INCH-POUND
MIL-W-48855C (AR)
AMENDMENT 5
29 June 1995
SUPERSEDING
AMENDMENT 4
28 FEBRUARY 1989

MILITARY SPECIFICATION

WARHEAD BODY ASSEMBLY
FOR
WARHEAD SECTION, GM, HE, M258

FIGURE 4. Powder Metal Preform Tensile Specimen

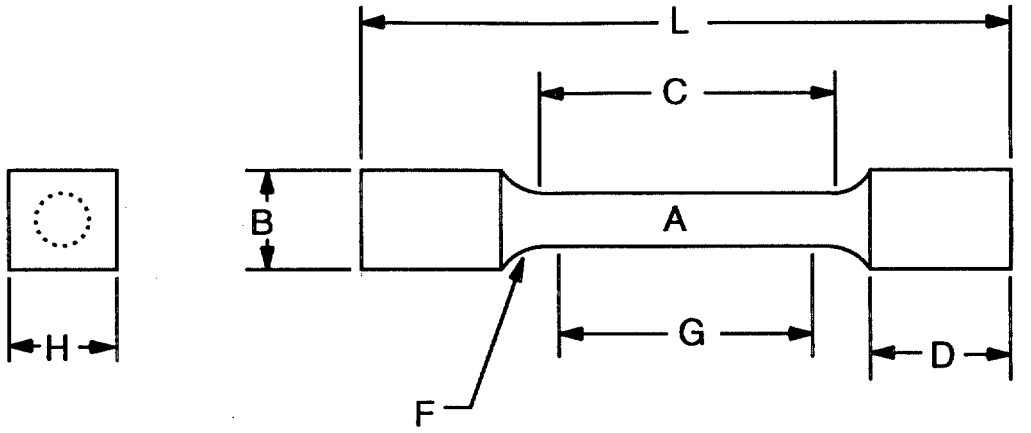
Add new Page 23A.

Add new Page 23B.

DIMENSIONS	
A- DIAMETER AT CENTER[1]	0.157 ± 0.001
B- WIDTH OF GRIP ENDS APPROX.[3]	0.250
C- LENGTH OF REDUCED SECTION MIN.	1.00
D- GRIP LENGTH, APPROX.[3]	1.250
F- FILLET RADIUS, MIN.[4]	0.250
G- GAGE LENGTH	0.750 ± 0.005
H- DEPTH OF GRIP ENDS APPROX.	0.250
L- TOTAL LENGTH, APPROX.[2,3]	4.00
AREA OF CROSS SECTION, SQUARE INCHES APPROX.	0.5

1. Diameter of the reduced section may be smaller at the center than at ends. Difference shall not exceed one percent of the diameter at the center.

2. When extensometer is required to determine elastic properties, dimensions C and L may be modified to provide therefor. In all cases the percentage of elongation shall be based on dimension G.

3. Ends may be of any shape to fit the holder of the testing machine such that the preform is tested axially.

4. A generous fillet is desirable.

FIGURE 5. Powder Metal Preform Impact Specimen

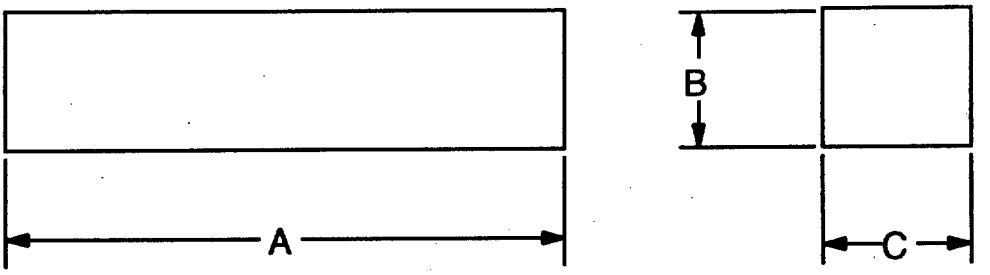
b. The yield specimens shall be obtained from the sidewall while the impact specimens shall be obtained from the base of the powder metal preform. The test specimens shall be produced of such dimensions so that the yield and impact test bars shall be machined to the form and dimensions shown in figures 4 and 5. Two test specimens of each type shall be machined from each body."

DIMENSION	MILLIMETER	TOLERANCE + mm -	INCHES	TOLERANCE + INCHES -
A- LENGTH	55.000	0.0 2.50	2.165	0.0 0.100
B- WIDTH	3.912	0.025 0.025	0.154	0.001 0.001
C- DEPTH	3.912	0.025 0.025	0.154	0.001 0.001
